Amendments to the Drawings:

Remarks/Arguments:

Fig. 1

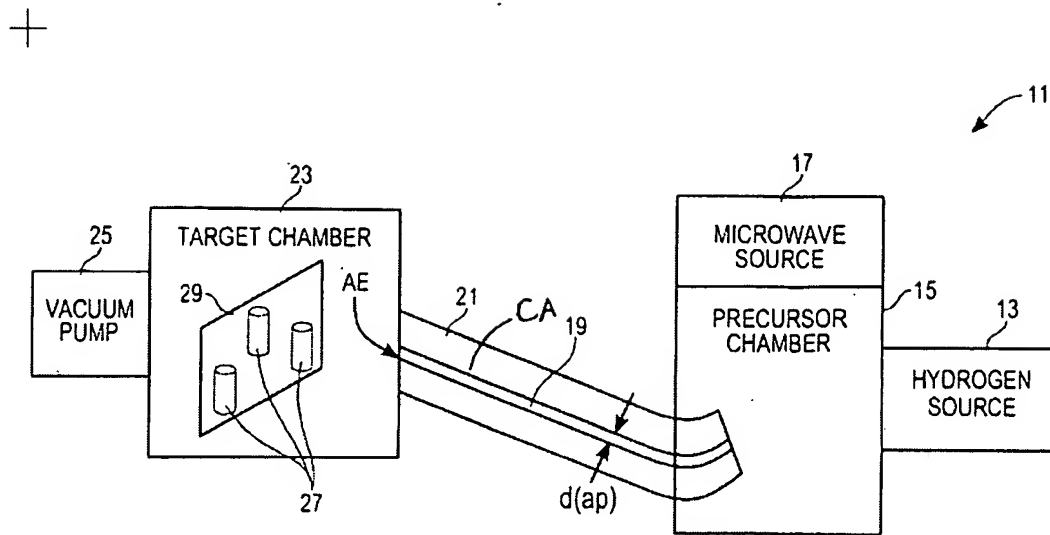
The Examiner objects to certain inconsistencies between the specification and the drawings, noting that the reference numeral 25, CA, 11", 21" and PS are present in the drawings but are not defined in the specification, and that reference numerals CA', CA" and 86 are mentioned in the specification but are not shown in the drawings.

The reference number 25 in Figures 1, 6 and 7 refers to a vacuum pump for a target chamber 23. The reference numeral CA which should, but does not, appear in Figure 1, refers to a central axis of an aperture or channel 19 between a precursor chamber 15 and a target chamber 23 and is discussed at page 6, line 17. The reference numeral 11', shown in Figure 6, refers to the system or apparatus shown in Figure 6. The reference numeral 11", shown in Figure 7, refers to the system or apparatus shown in Figure 7. The reference PS, shown in Figure 8, refers to a production site in a precursor chamber 85 and is discussed at page 10, line 23, and at page 11, line 5. A proposed amendment to Figure 1 is presented that adds reference numeral CA. The specification is amended at page 4, line 5, and at page 8, lines 17 and 28. The Applicants believe that, with these proposed amendments implemented, the inconsistencies between drawings and specifications are resolved.

Proposed amendment shown in red

Fig. 6

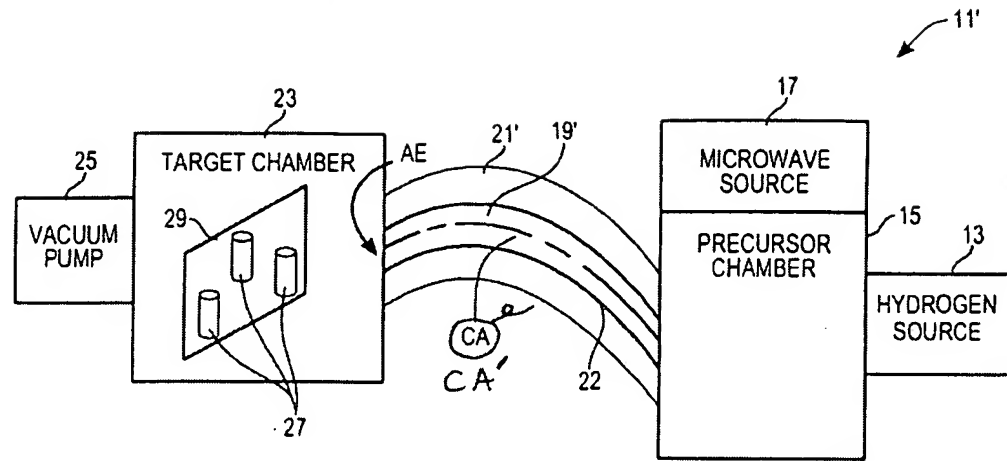
Proposed amendments to Figures 6, 7 and 8 are presented here to change CA to CA' (Figure 6), change CA to CA" (Figure 7), and add reference numeral 86 to Figure 8.
